**PRELIMINARY EVALUATION AND ANALYSES OF THE
U.S. DEPARTMENT OF ENERGY GEOTECHNICAL
DATA FOR THE WASTE HANDLING BUILDING SITE
AT THE POTENTIAL YUCCA MOUNTAIN REPOSITORY**

**U.S. Nuclear Regulatory Commission
Contract NRC-02-02-012**

**Center for Nuclear Waste Regulatory Analyses
San Antonio, Texas**

June 2004

Figure 2-3. East-West Slice of EarthVision® Model Layer Tpcrn Showing Change in Displacement Along Fault Surface. View Is to the South with No Vertical Exaggeration. Coordinates are UTM, Zone 11.

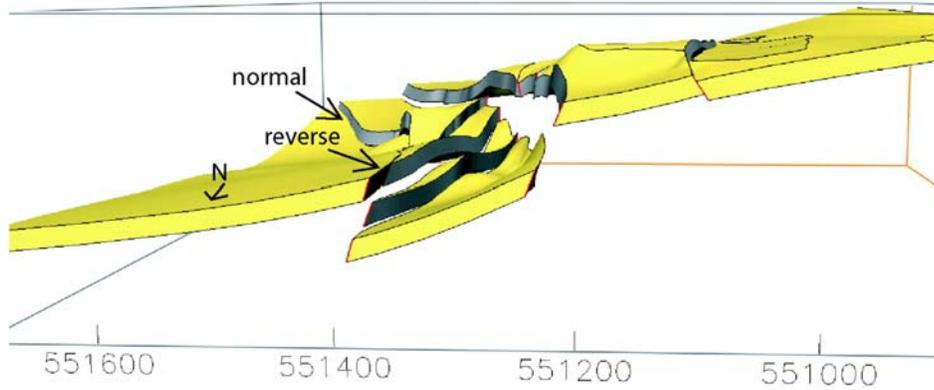
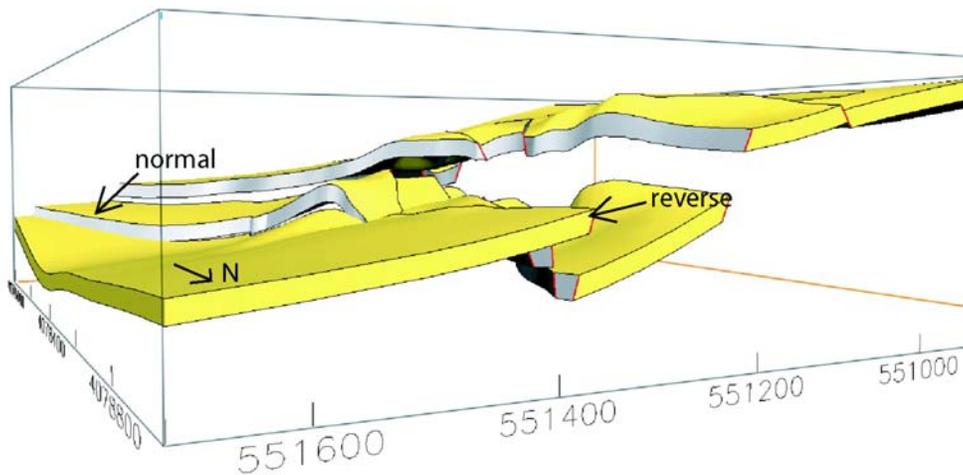
- Along its tract, Fault 12 appears as both a normal and reverse fault, which can be seen in the EarthVision® model (Figure 2-3 and Figure 2-4). The problem with Fault 12 could

be alleviated by the addition of a normal fault in the far eastern part of the model, perhaps outside the proposed Waste Handling Building site.

Figure 2-5. EarthVision® Model Exhibiting the Small Offsets of Faults 1, 2, 3, and 4. View Is to the North With No Vertical Exaggeration. Model Is Sliced at Northing 4078481. See Figure 2-1 For Map View of Fault Locations.

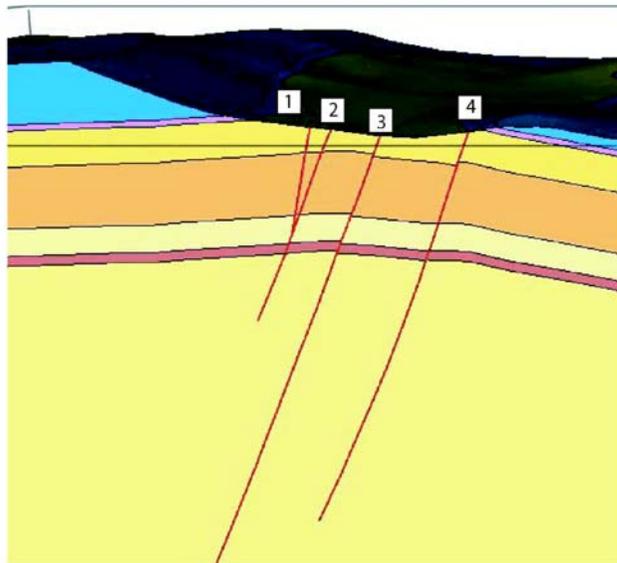
- Faults 1, 2, 3, and 4 have very small offsets [Figure 2-5 and Bechtel SAIC Company, LLC (2002) cross sections A, E, F, and G]. It is unclear why faults were interpreted by the DOE in these locations. Also, it is unclear why Faults 1, 2, and 3 are interpreted to be reverse faults. The interpretation in Bechtel SAIC Company, LLC (2002) that Fault 3 is a major structure spanning the entire study area should be reexamined, since the fault appears to have only a small offset.
- A structural high in the southeast indicates a possible missing fault (Figure 2-6). The structural high could be explained as a relay ramp fault connecting displacement along the two segments of Fault 12.

Figure 3-4. Composite Shear-Wave Velocity Profiles Based on the DOE Data from Conventional Downhole, Suspension Surveys, and Spectral Analysis of Surface Waves Results

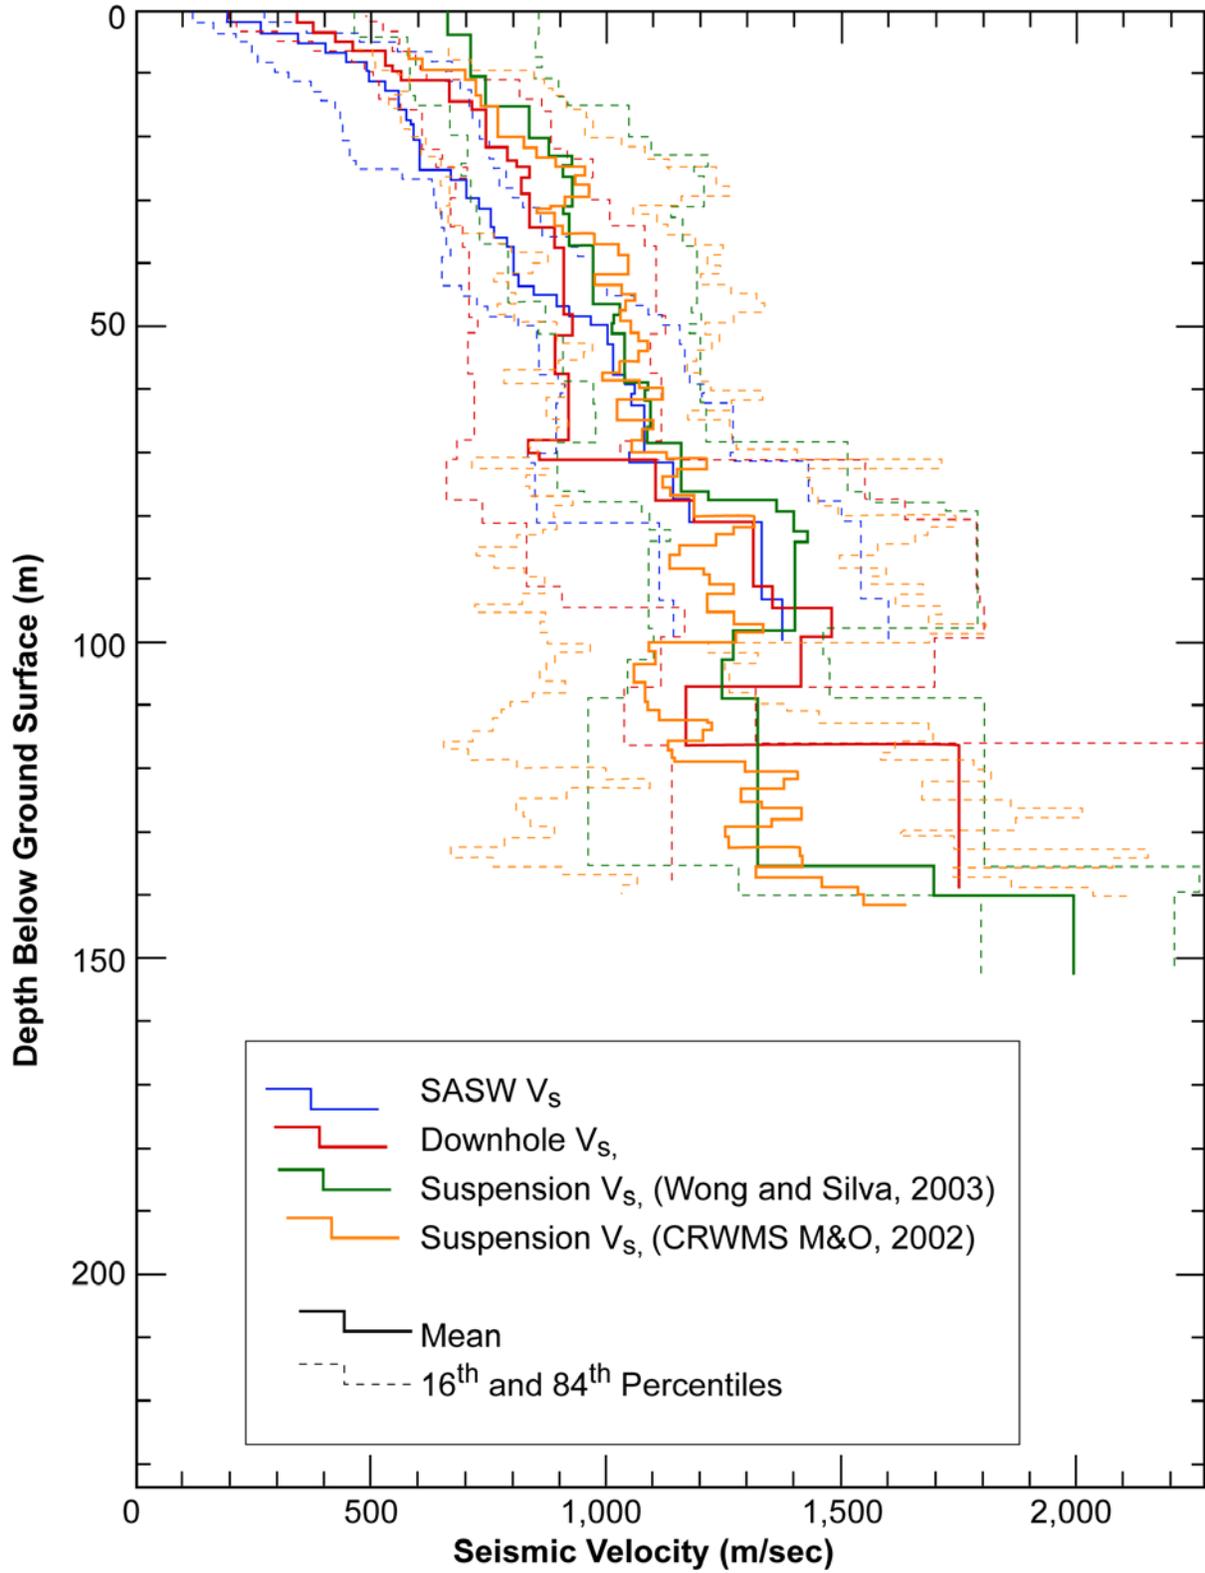
Despite noted differences in V_s among the three measurement methods (conventional downhole, suspension, and spectral analysis of surface waves); overall results in terms of velocity trends are comparable (Figure 3-4). Of the four data sets for velocity, we used the source-to-receiver suspension data because they were most easily correlated with stratigraphy. In Bechtel SAIC Company, LLC (2002), the suspension results are presented within small enough depth interval that we could bin the data within each stratigraphic unit. In contrast, the conventional downhole V_s and V_p profiles were developed from eyeball fits to linear segments of the data without regard for stratigraphic position or lithology. These processed velocity data and smoothed spectral analysis of surface wave data do not easily lend themselves to correlation with stratigraphy.

Figure 3-9. Normalized Shear Modulus Data for the Tuff Samples from the Proposed Waste Handling Building (Modified from Bechtel SAIC Company, LLC 2002). Also Shown are Average, Upper, and Lower Bound Sand Curves and a Standard Rock Curve.

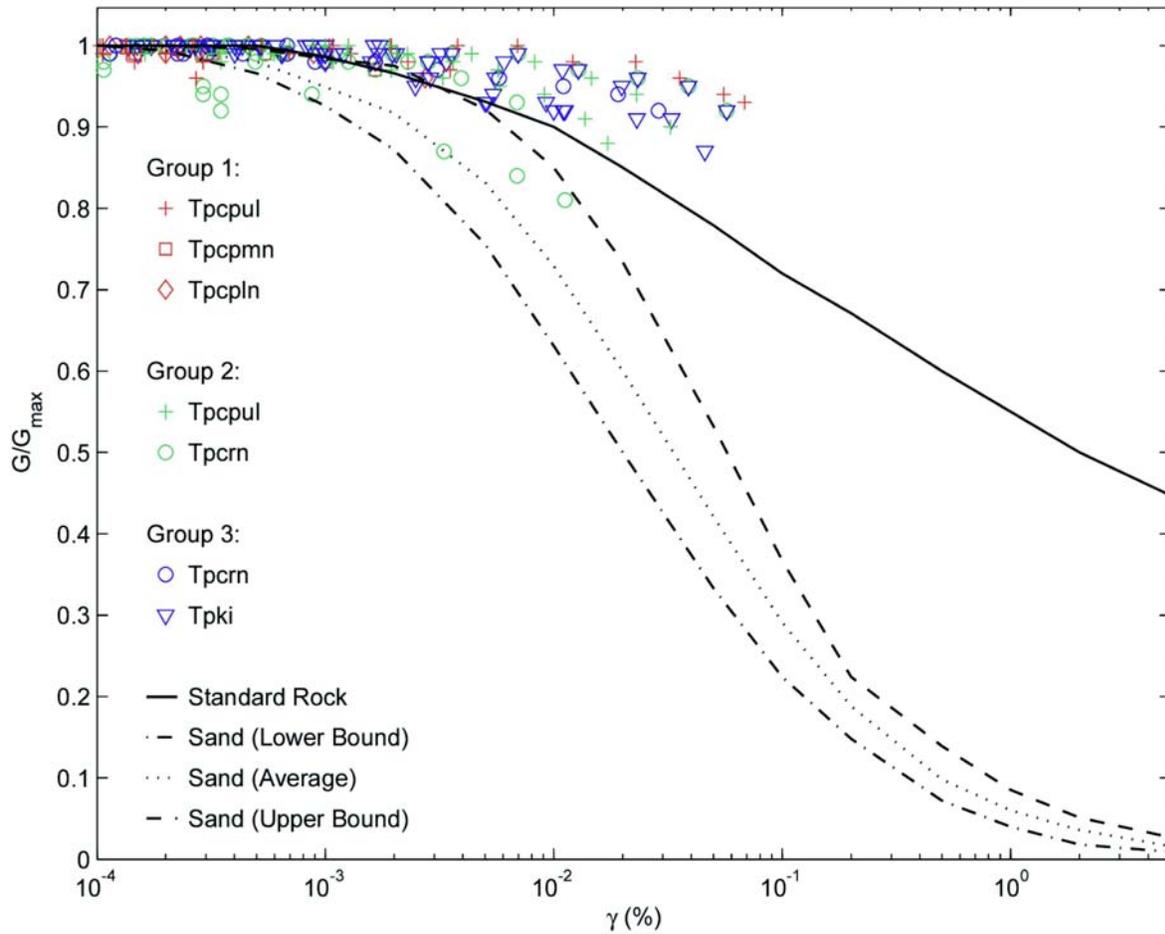
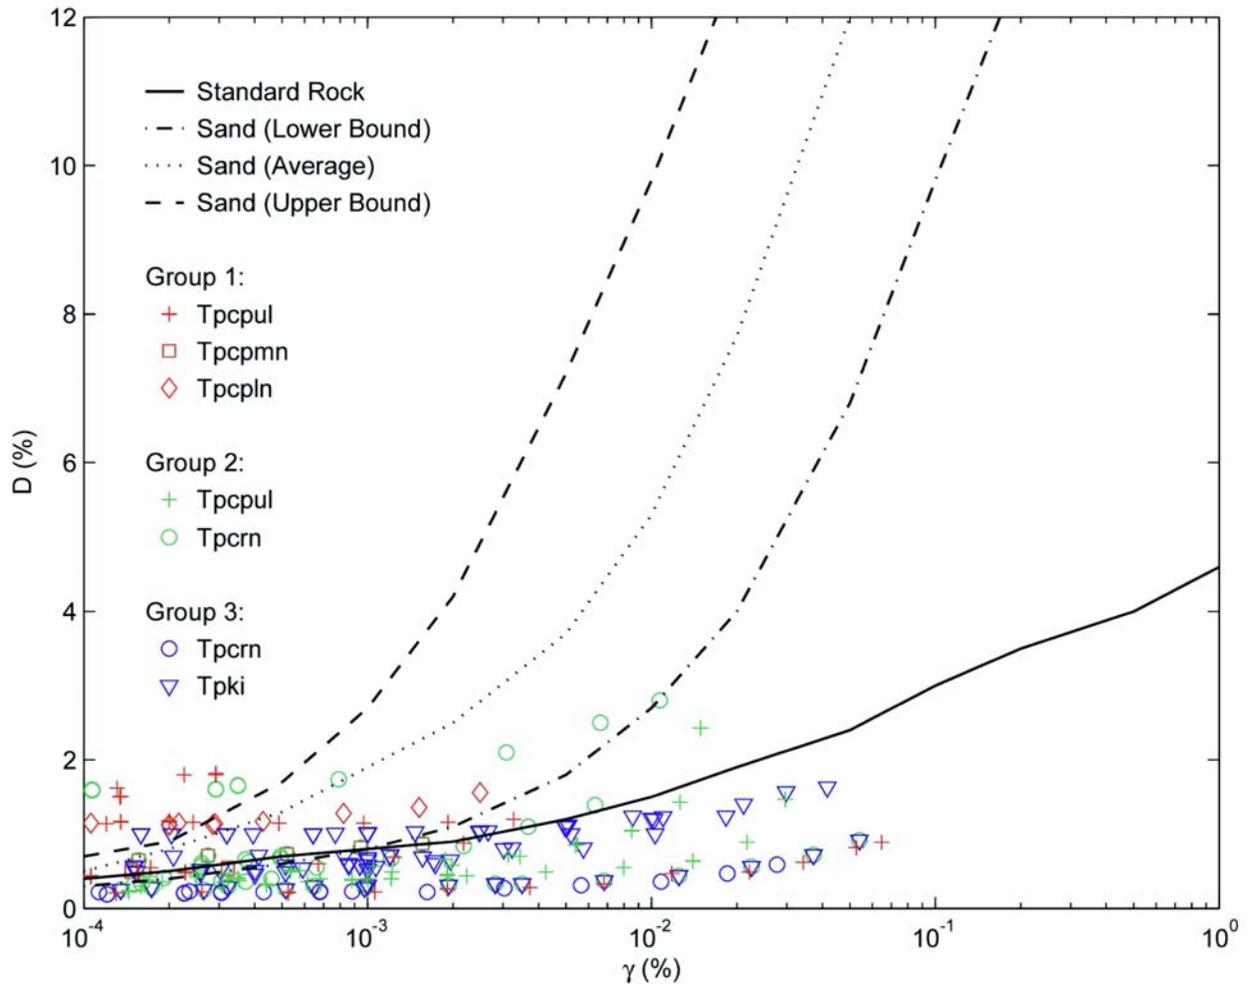
Overall Figures 3-9 and 3-10 do not reveal a strong correlation among the three groups' dynamic behavior. There is large uncertainty in the dynamic behavior of the tuff specimens at strain levels beyond 0.1 percent. This is a limitation of the resonant column and torsional shear testing equipment. For some tuff units however, including the densely welded units Tpcpmn and Tpcpln, data are limited to strain levels of approximately 0.003 percent. The large uncertainty in dynamic behavior may be significant for larger earthquake motions which may produce strains beyond these values.
